**585 Third Street
Cambridge, Massachusetts**

PB-383

PUD Special Permit Presentation

January, 2022

Elevations

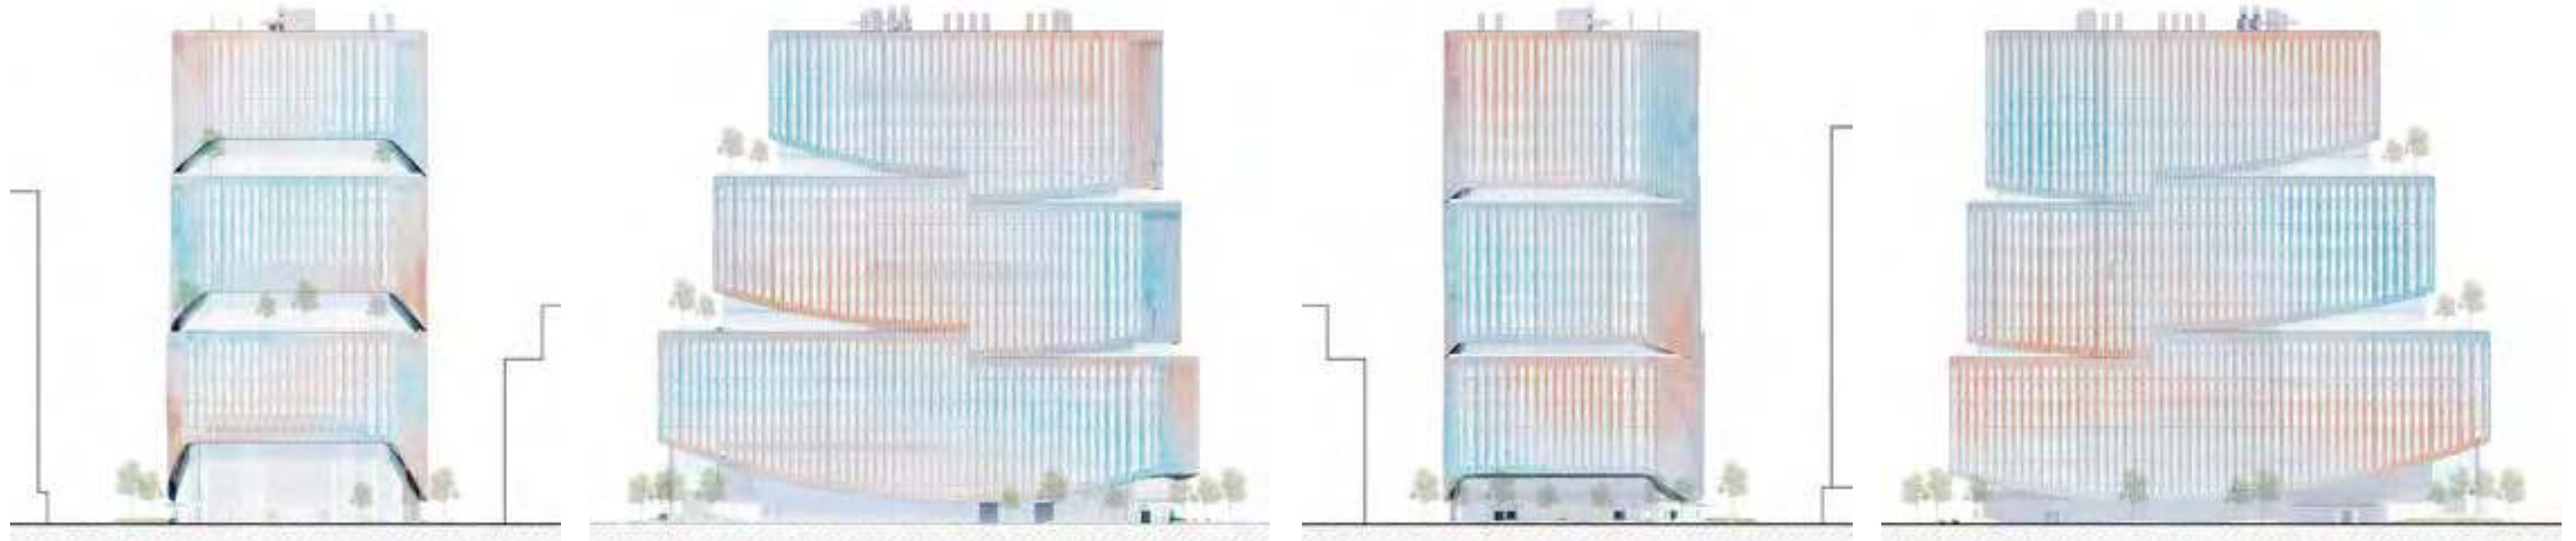
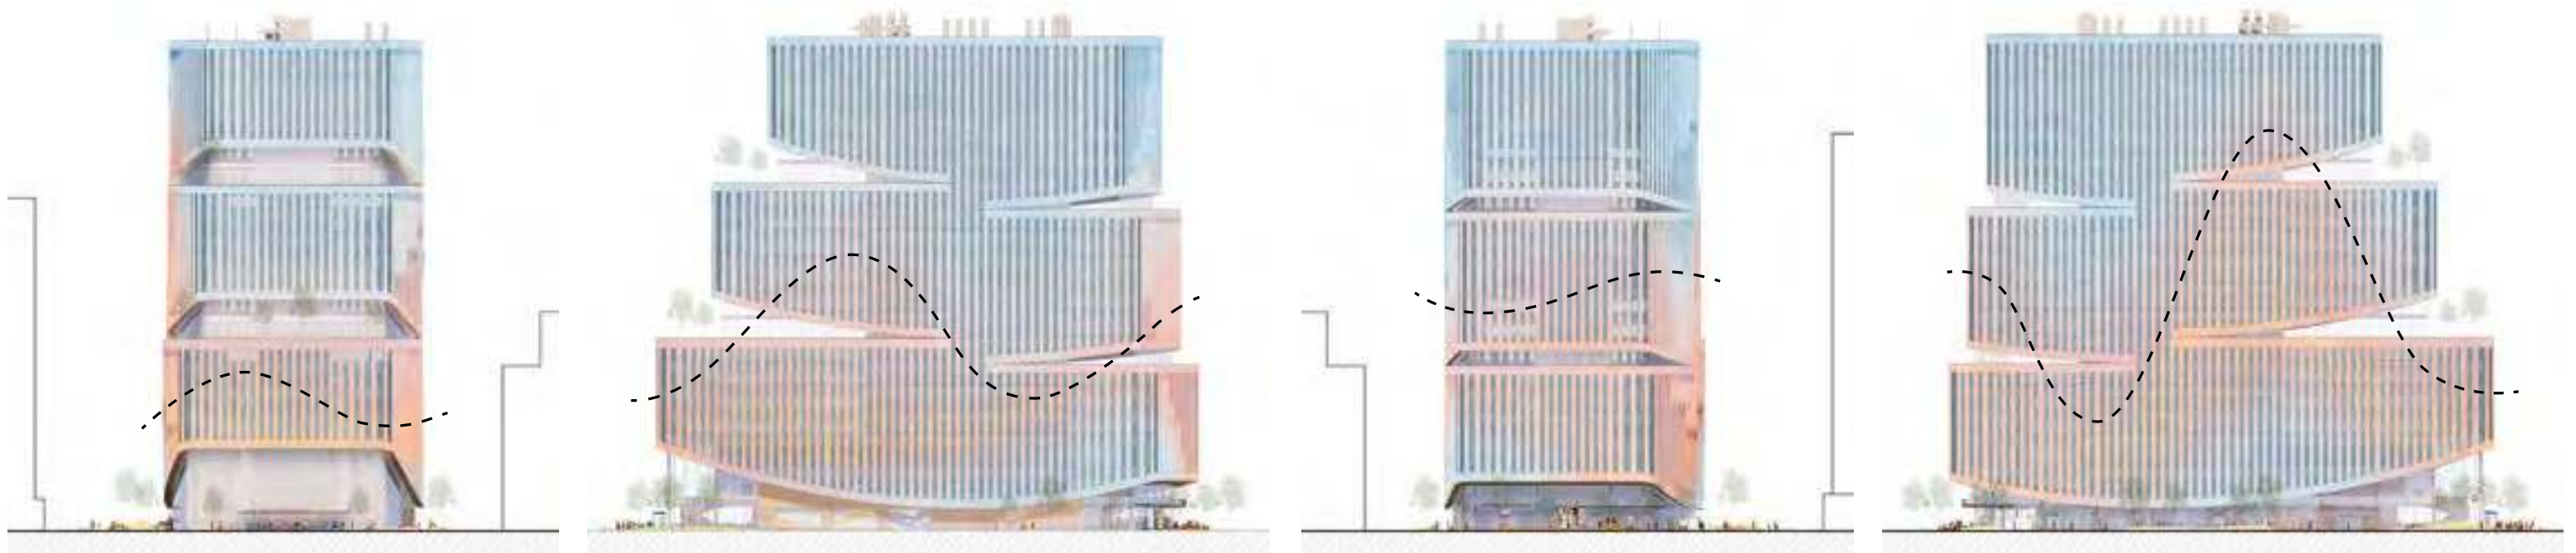
- Consideration of additional distinction between primary front and rear
- Material color palette and samples
- Gloss finish of facade material

Rooftop Axonometric View

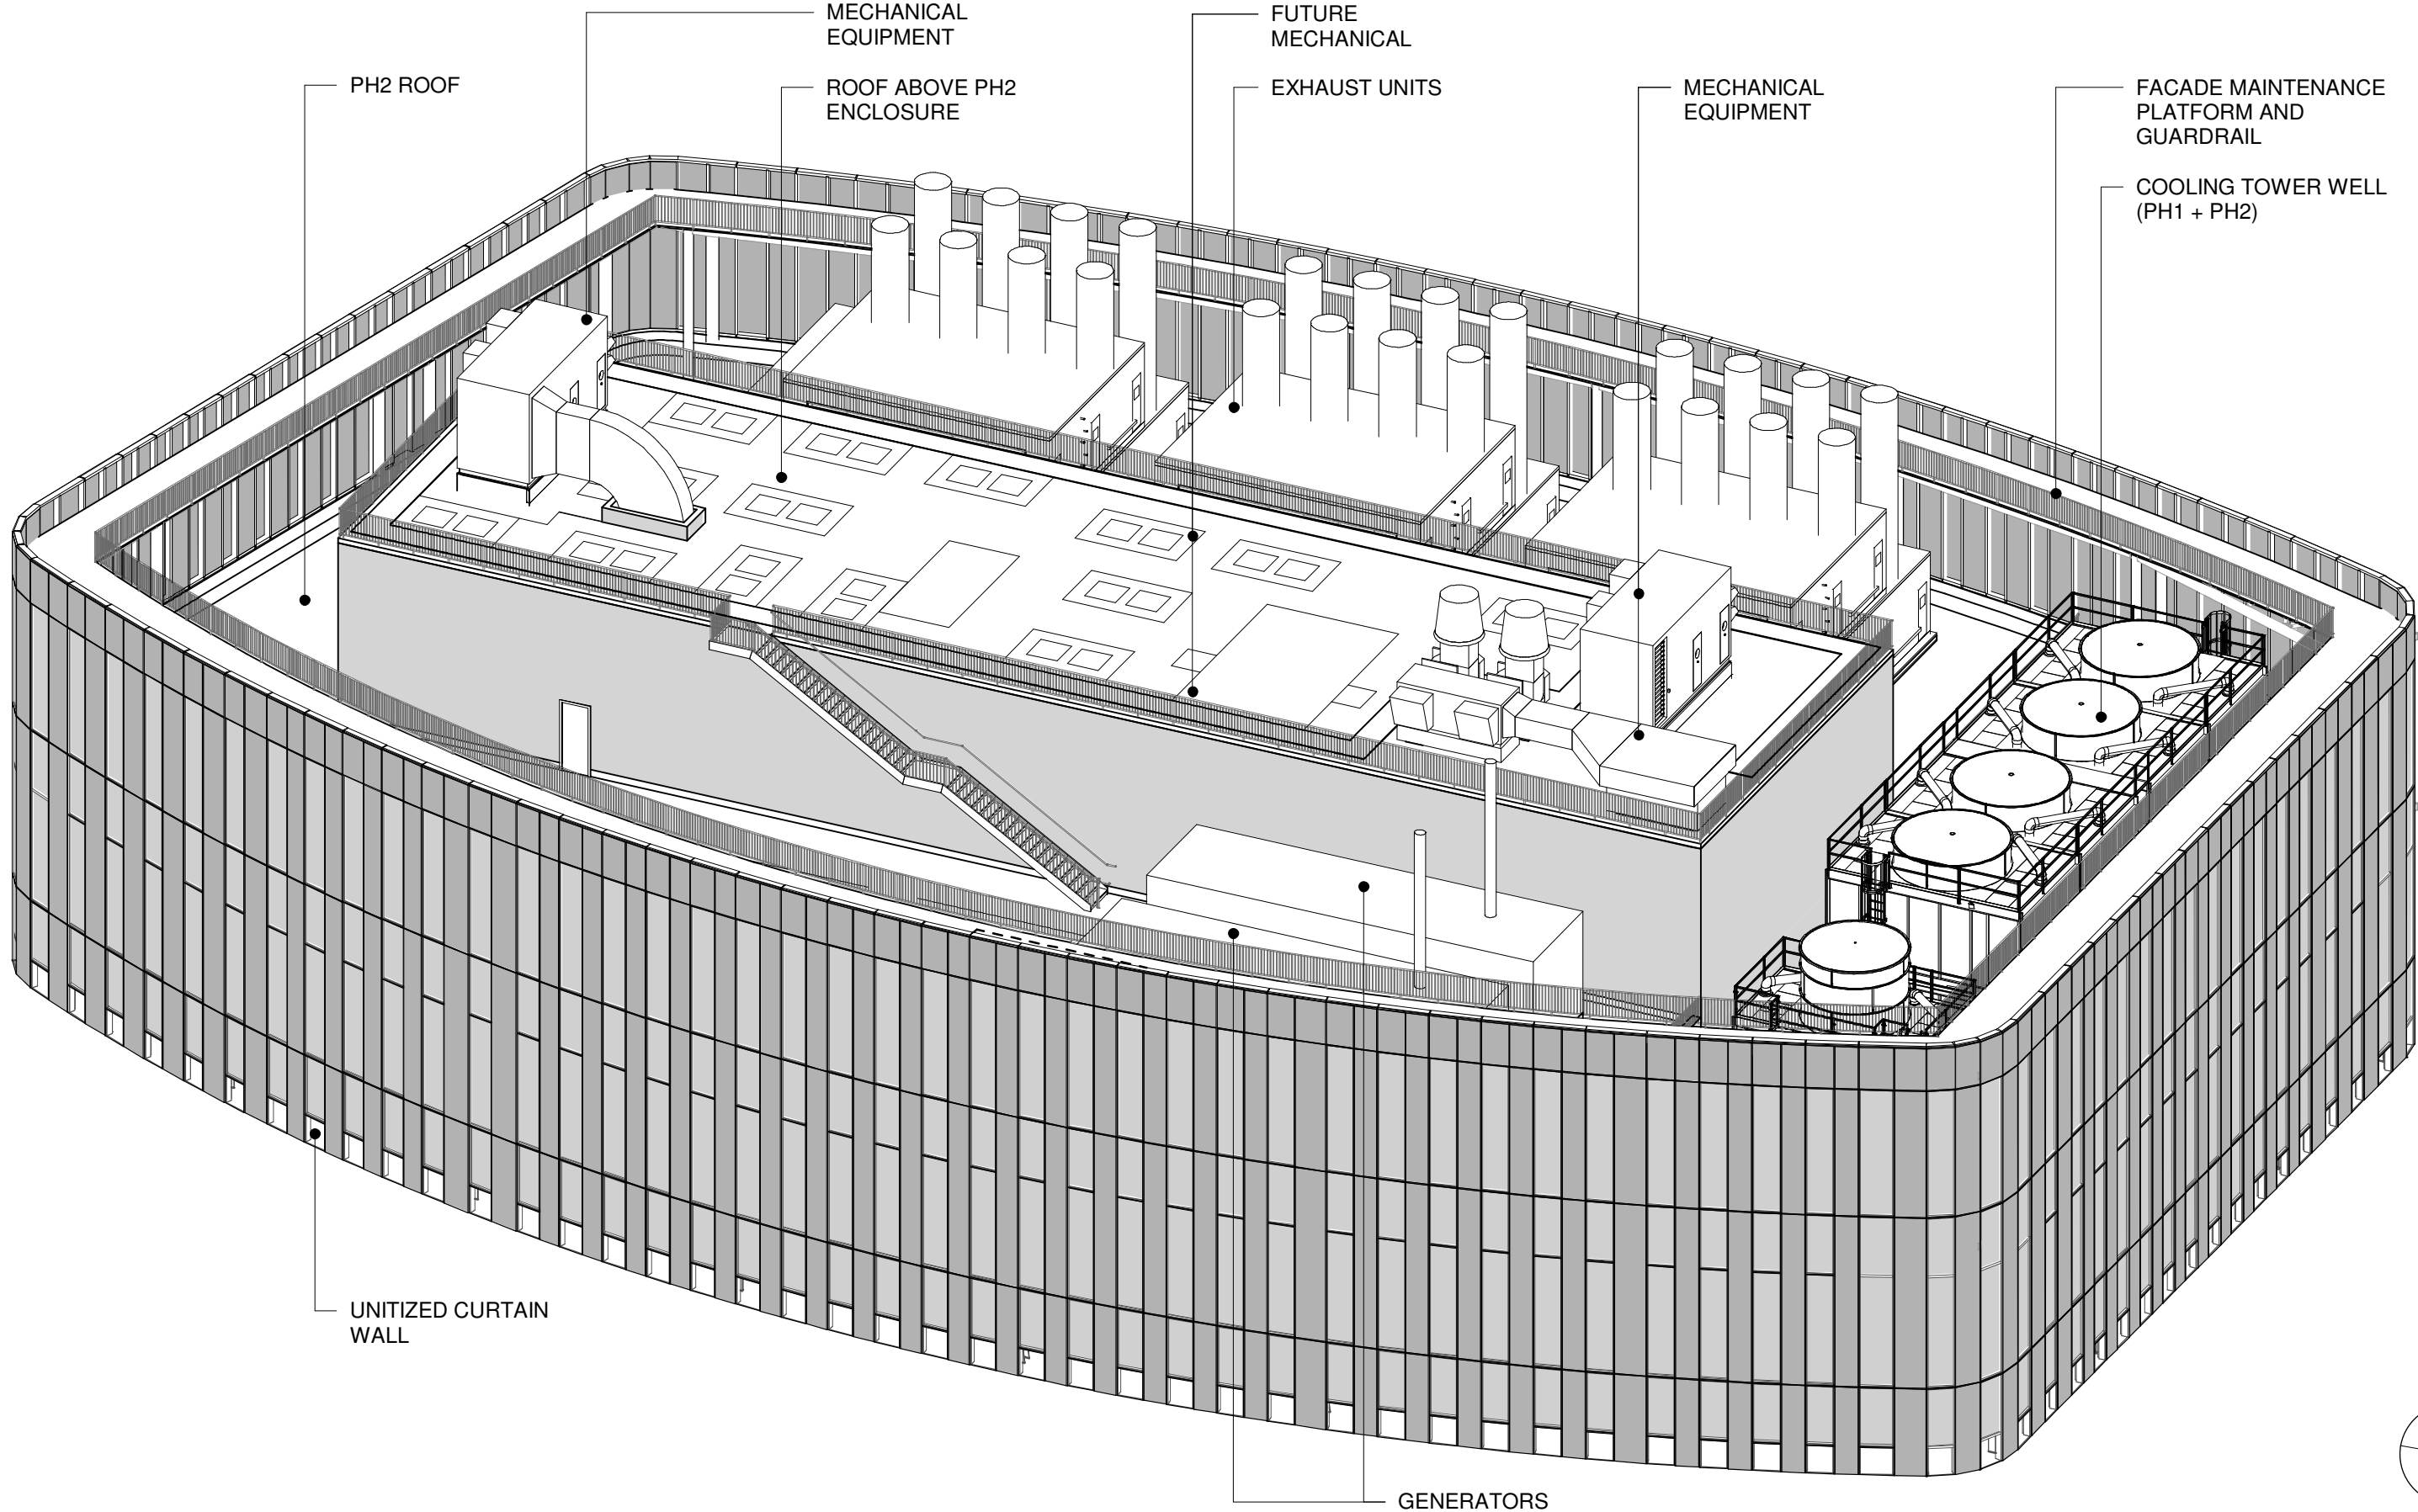
- Opportunities to provide screening for exposed lab stacks

Overall Landscape Plan - Revised Design

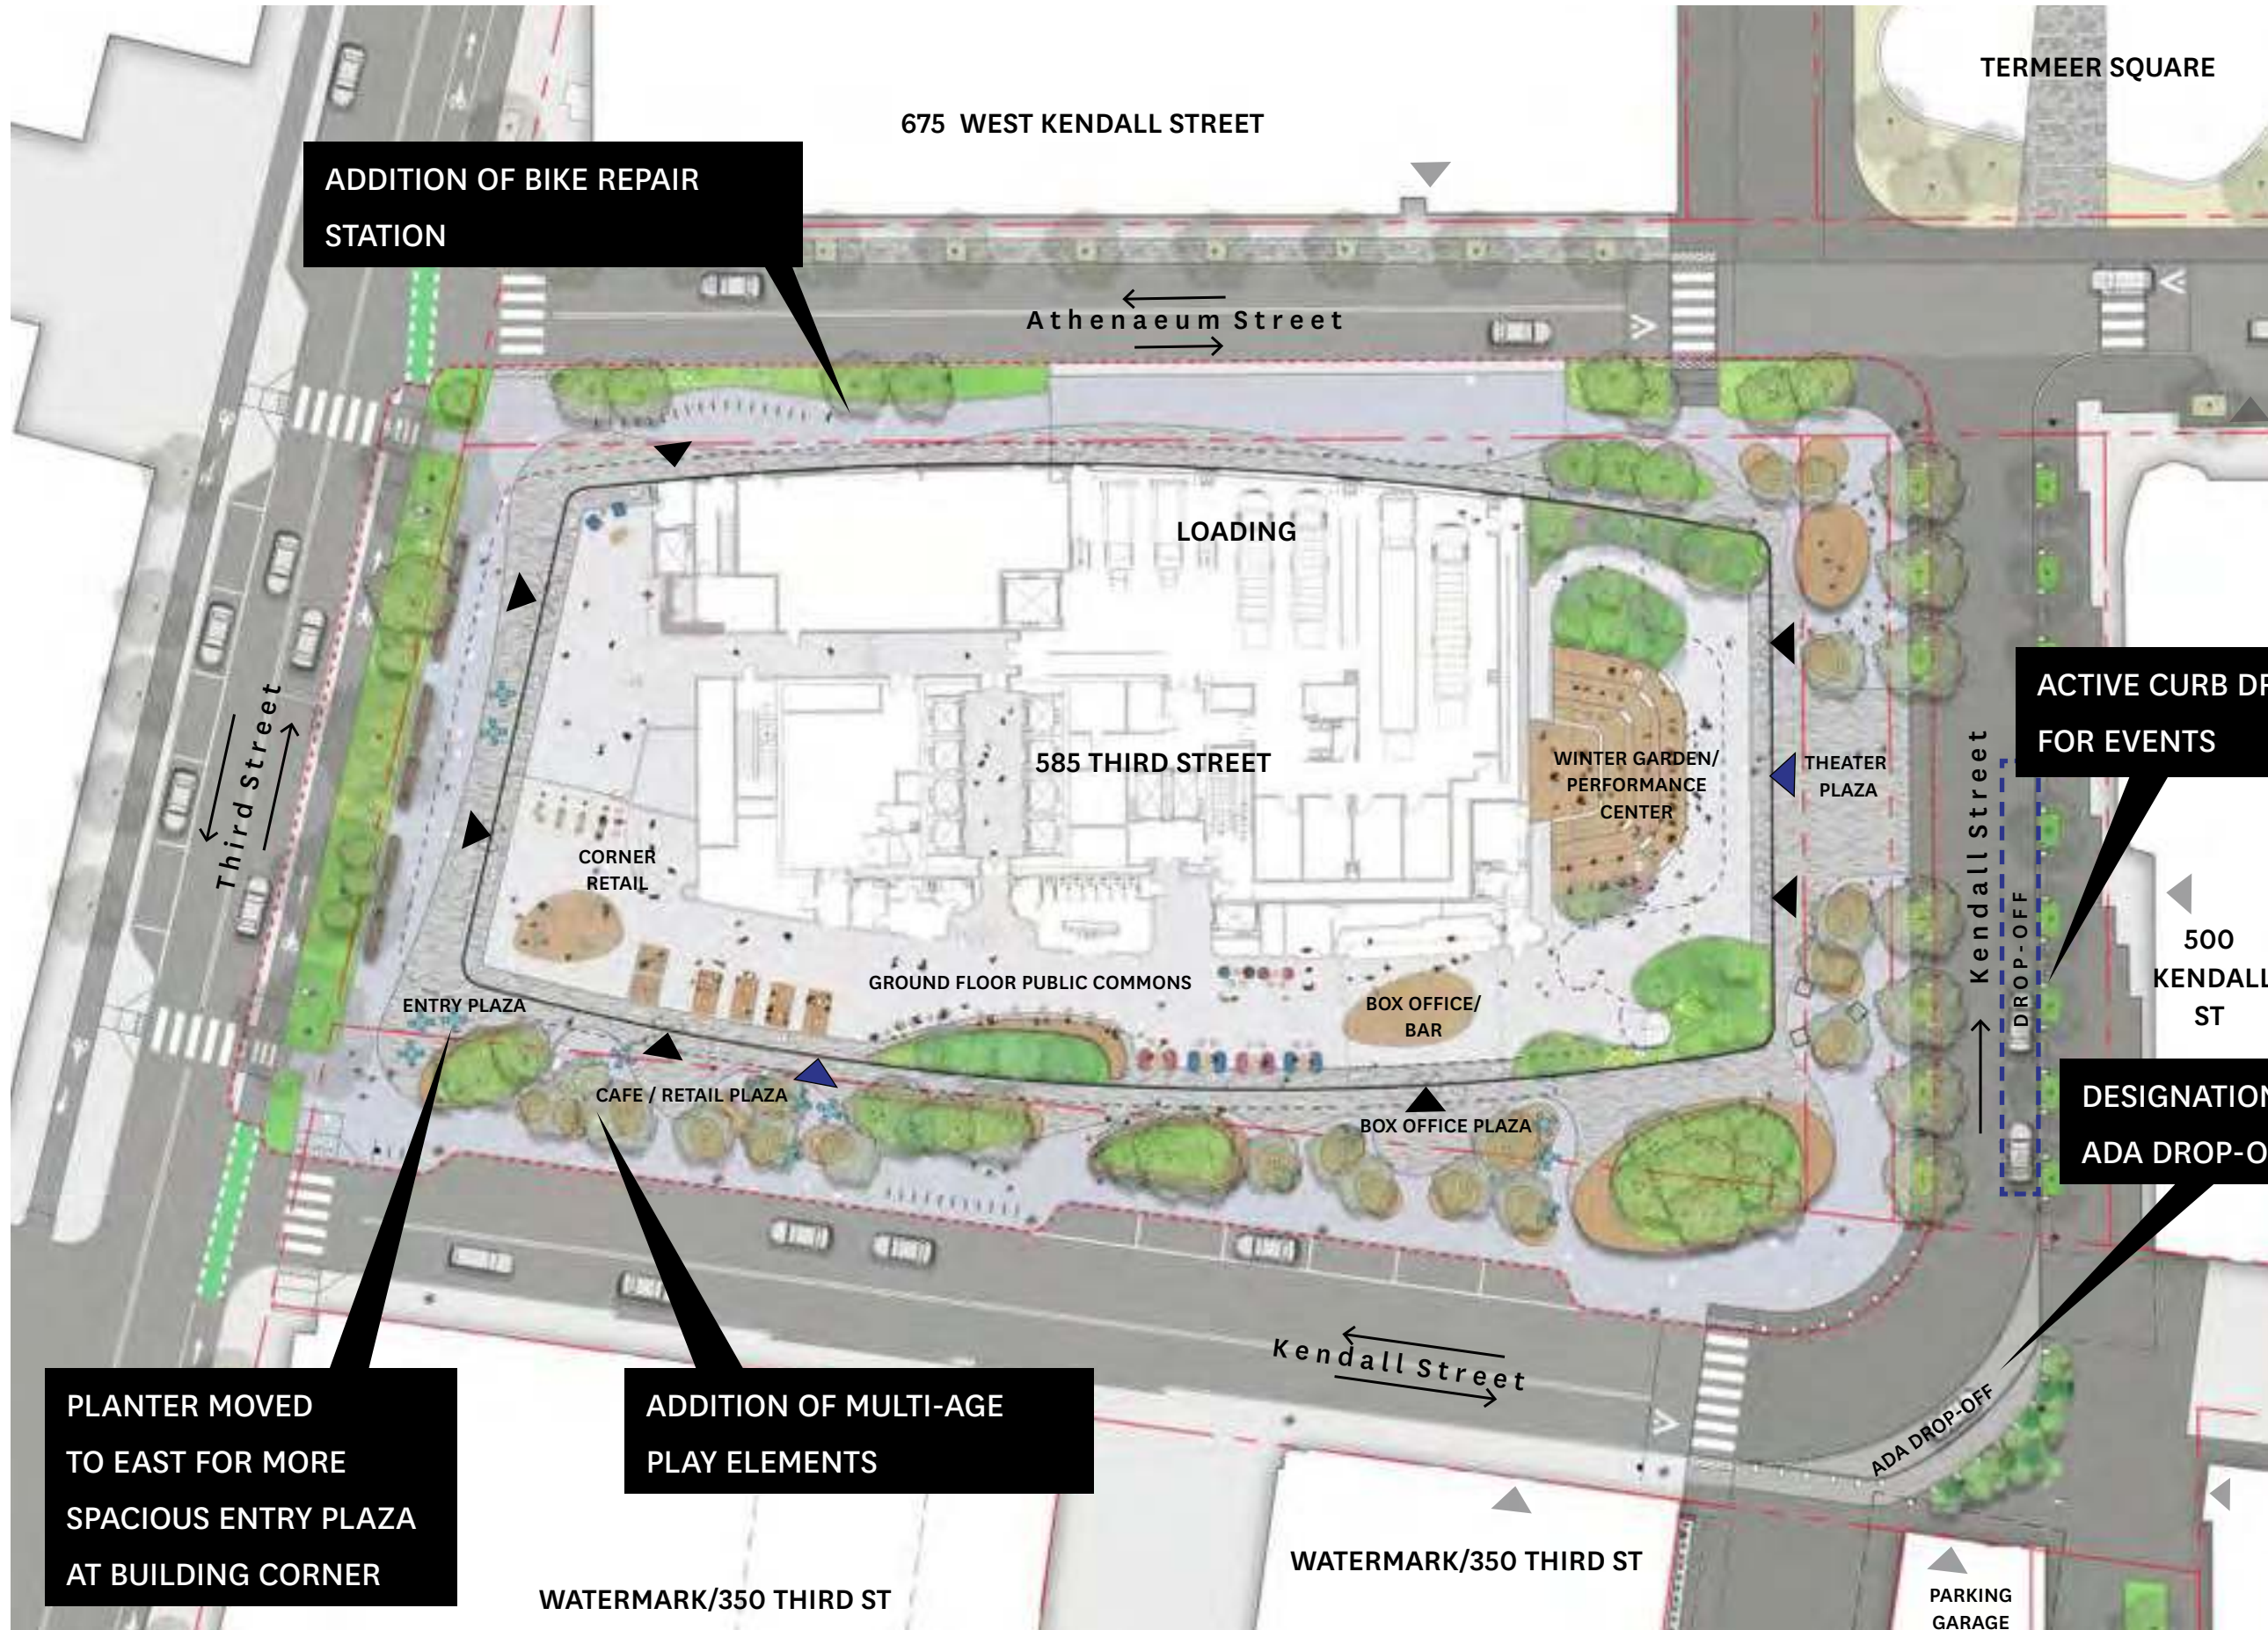
- More information about the proposed oval planting beds, and opportunities to redesign them so as to avoid creating physical and visual barrier between the public realm and the ground floor of the building.
- More information related to the proposed character of each landscape/open space zone, including opportunities to integrate public art and play for both children and adults.
- Landscape plans for the upper story terraces.
- Clarification of the landscape views provided in the building renderings as they appear to be different.

- Opportunities to provide landscaping (low in height) around the proposed Bluebikes station.
- Opportunities to provide publicly accessible bike air pumps and repair tools.
- Address Theater drop off logistics.

ADDITION OF BIKE REPAIR STATION

ACTIVE CURB DROP-OFF FOR EVENTS

DESIGNATION OF ADA DROP-OFF

PLANTER MOVED TO EAST FOR MORE SPACIOUS ENTRY PLAZA AT BUILDING CORNER

ADDITION OF MULTI-AGE PLAY ELEMENTS
